PROJECT BORN FRAGRANCE - shop fit-out

SHEET SD-02

TITLE DISPLAY / FURNITURE PLAN

REV 00 - preliminary

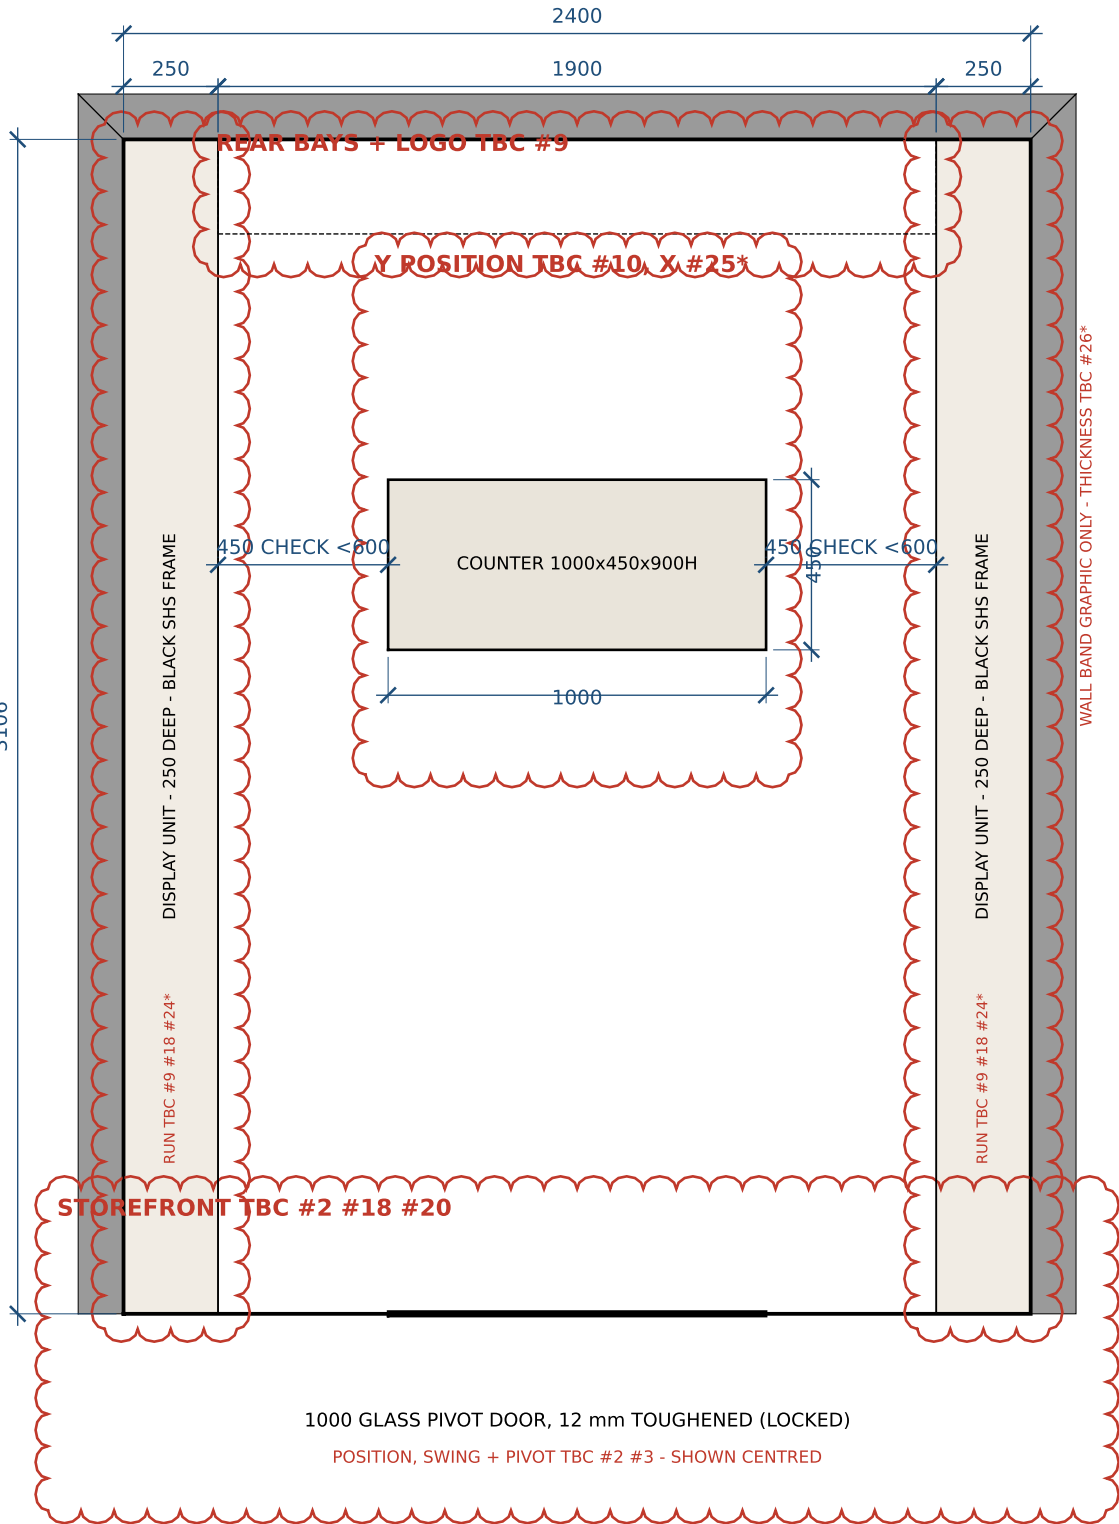
Counter centred x 700-1700 is a PROPOSAL.
Side clearance 450 < 600: CHECK staff access.
Exclusions: no timber, brass, plants, products.

BAYS ~600, COUNT TBC #24*
BASE CAB TBC #7

- #7 Base cabinet height and door type
- #9 Rear wall bay width, shelf count, logo size and height
- #10 Counter distance from rear wall and staff clearance
- #13 Floor-level LED strip (visible in render): keep or omit
- #18 Storefront display column depth, and shelf facing (street, shop or both)
- #24* Side bay count, widths and upright spacing
- #25* Counter lateral position (centring is a proposal)
- #4 Is 2400 x 3106 the finished size (after plaster)?
